Remarks/Arguments:

Applic. No. 10/791,539  
Amdt. dated November 9, 2005  
Reply to Office action of August 9, 2005

Drawing Amendments

FIG. 2  
~~Fig. 2~~

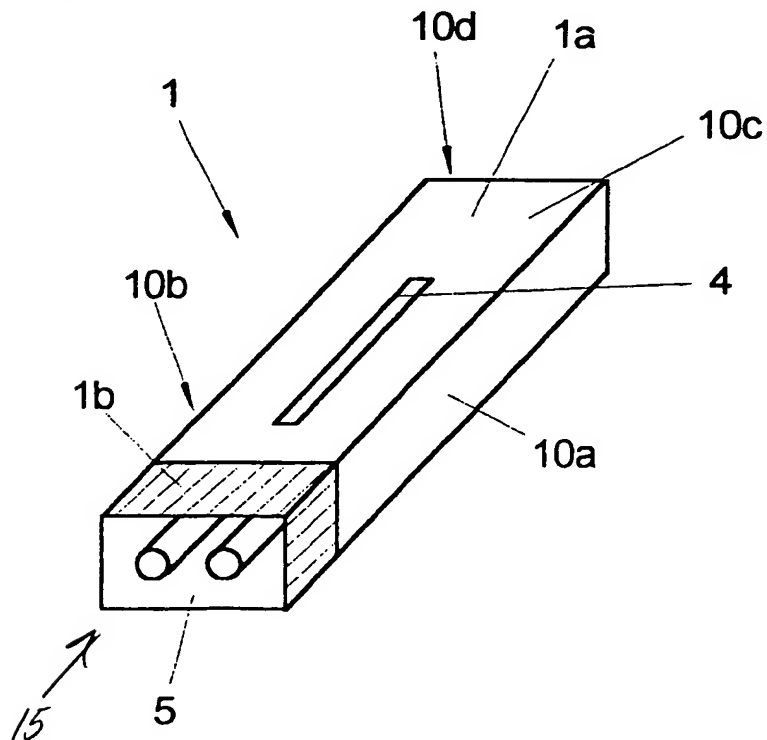
The Examiner has stated that the electrical component/transceiver must be shown or the feature cancelled from the claim. Figs. 2, 3, and 4 have been changed to include the reference numeral "15" directed to the optoelectronic component. Furthermore, the specification was amended to include the reference numeral "15". Therefore, the objection to the drawings by the Examiner is believed to have been overcome.

The attached sheets of drawings include changes to Figs. 2, 3, and 4. These sheets which include Figs. 1-4, replaces the original sheets including Figs. 1-4. In Figs. 2, 3, and 4, reference symbol "15" was added to indicate the optoelectronic component.

Please approve the drawing changes that are marked in red on the accompanying "Annotated Sheet Showing Changes" of Figs. 2, 3, and 4. Formal "Replacement Sheets" of amended Figs. 2, 3, and 4 are also enclosed.
